# Rathborne Village Residents Committee

DART+ West Oral Hearing (ABP-314232-22)

Sep-Oct 2023

## Environmental impact – Loss of trees and vegetation(1 of 3)

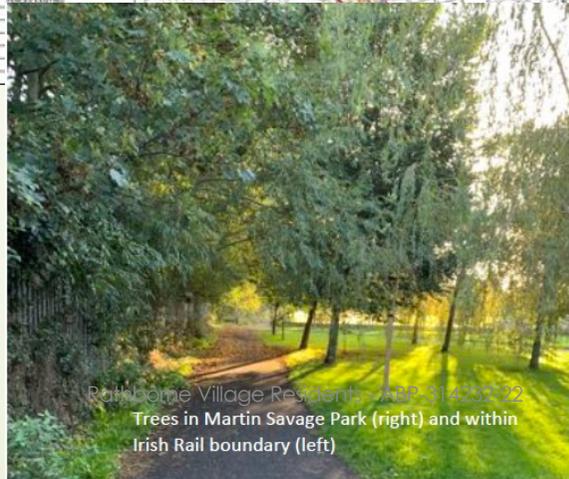
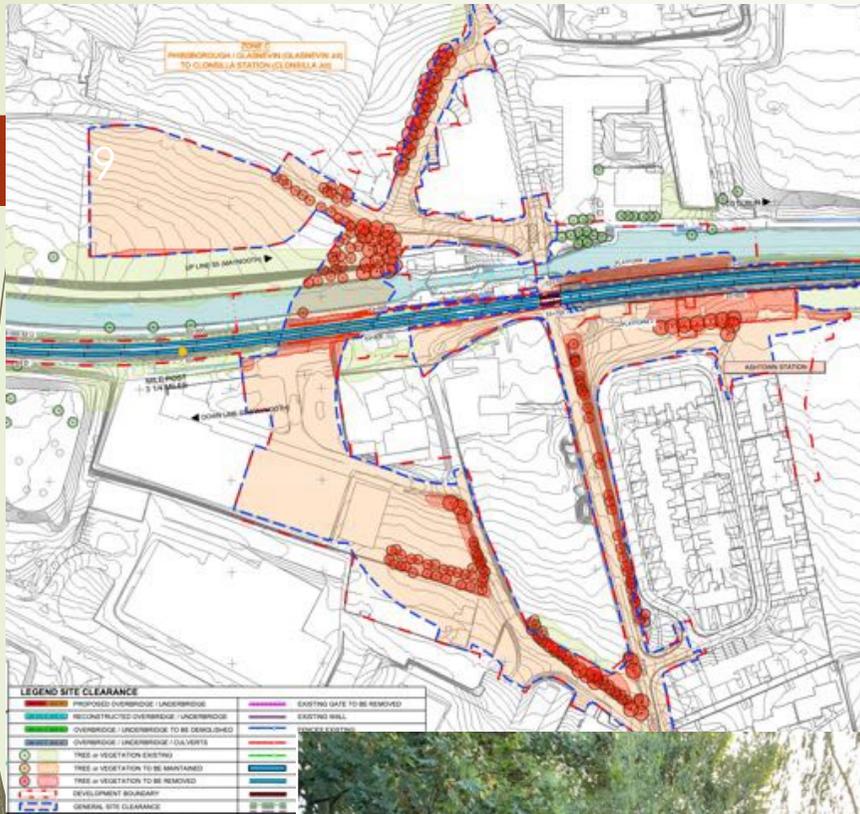
We propose that any approval of the railway order application is subject to the condition that Irish Rail (1) conduct an Arboricultural Impact Assessment and share it with An Bord Pleanála and the public prior to approval to proceed with DART+ West works; and (2) evaluate how the level of tree and vegetation loss can be minimised from the DART+ West project compared to current proposals.

- ▶ Similarly, **we reiterate our request in our initial submission that Irish Rail (1) conduct an Arboricultural Impact Assessment and share it with An Bord Pleanála and the public prior to approval to proceed with DART+ West works; and (2) evaluate how the level of tree and vegetation loss can be minimised from the DART+ West project compared to current proposals.**

“Vegetation will be retained where practicable”

The loss of habitat to facilitate construction at Ashtown is described in Vol. 2 Chapter 8 Biodiversity, Section 8.8.2.1, which states that “An underbridge is proposed at Ashtown which will **result in the loss of one hectare of agricultural and built land and approximately 400 m of treelines/hedgerows.** ...

The loss of trees and hedgerows is acknowledged in the EIAR. Section 15.5.1.1.3 States “**The sensitivity of the streetscape / townscape in this local area of Ashtown is ‘high’. The magnitude of change will be ‘very high’ and the likely effects in the construction phase will be very significant, negative, short-term.**” Replacement planting will be provided to mitigate the loss of this vegetation.

## Environmental impact – Loss of trees and vegetation – bike parking (1 of 2)

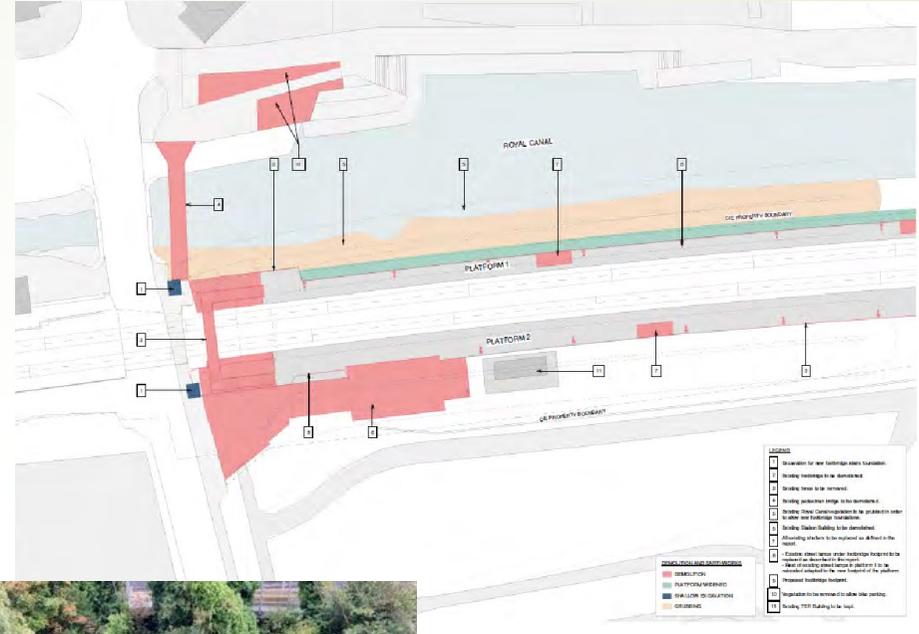
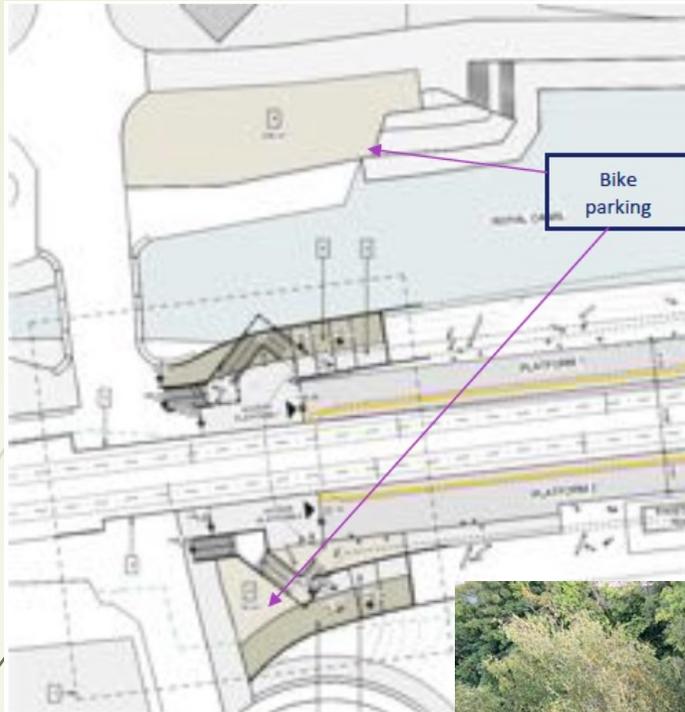
Our submission	Irish Rail response	Our further response
<p>We propose that any approval of the railway order application is subject to the condition that Irish Rail (1) re-assess the distribution of bicycle parking north and south of the canal and railway at Ashtown, making changes as relevant; (2) re-assess the area being taken for bicycle parking at Ashtown compared to the area determined by its own assessment; and (3) minimize the extent of removal of vegetation and oak trees located in the proposed bicycle parking location north of the canal.</p>	<p>37 bicycle parking spaces are needed at Ashtown Station. Bicycle's spaces provision is calculated based in the National Cycle Manual Section 5.5.7 "How much parking – Cycle parking Guidance", which states a guidance of minimum number of spaces that should be provided initially at new private and public facilities in urban areas. It has been considered that a space of 61 m<sup>2</sup> is sufficient to include the required 37 bicycle parking spaces.</p>	<p>We do not believe that the issue raised in our submission has been appropriately addressed. 230m<sup>2</sup> is being allocated to the north of the canal (area mentioned above) with a further 70m<sup>2</sup> at the south of the railway. It is not clear why the areas each side of the canal are so unevenly distributed, or why such a large area is needed relative to Irish Rail's own analysis. Greater dispersion of bicycle parking between both sides of the railway could minimize the impact on vegetation and trees north of the canal.</p>

# Cumulative construction impacts (1 of 3)

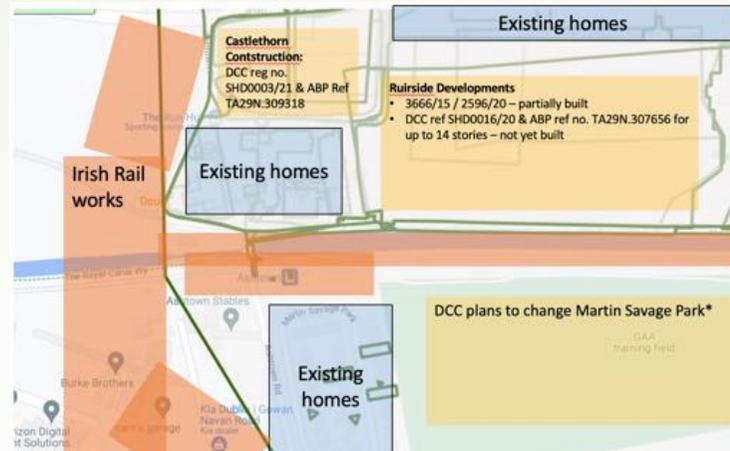
We propose that any approval of the railway order application is subject to the condition that Irish Rail engage with Castlethorn construction and, if necessary, Dublin City Council, where there is contemporaneous development of sites surrounding Rathborne Village and DART+ West construction to: (1) assist in the application of similar mitigating actions in terms of dust and pollution for residents of the area; and (2) coordinate activities to minimize the impact on the area.

- Similarly noise levels are known to cause stress to both humans and wildlife.
- **Given there is potential for 3 building sites to be in action at the same time and that there are 100+ children living in Rathborne Village, it is imperative that appropriate mitigating actions are coordinated between Irish Rail and the developers of both sites in the event that construction activity overlaps. We would like such action to be embedded as a condition in the plan, alongside the involvement of Dublin City Council.**

The cumulative effects arising from the proposed development with other existing and/or approved plans and projects during the construction and operational phases of DART+ West project can be found in Chapter 26 Cumulatives. Table 26-6 Tier 3 Projects within the functional area of Dublin City Council, of Section 26.3.1.2 has included the Planning Applications of Ruirside Developments (EIA Portal ID 2020109, DCC reg no. SHD0016/20 & ABP ref no. TA29N.307656) and Castlethorn Construction Unlimited (DCC reg no. SHD0003/21 & ABP Ref TA29N.309318). The EIAR for **Ruirside Developments** (Stephen Little & Associates, 2020) **indicates that the construction phase will be in two phases, with the first phase commencing 2021 and completing in 2023, and the second phase commencing in 2023 and competing in 2026.** The construction programme indicated for the **Castlethorn Construction Unlimited development is indicated to commence in the second half of 2021, with a 30 month programme.** Therefore, there is only a likely overlap of construction phases with the DART+ project (with construction anticipated to commence in 2024) and the Ruirside Developments.
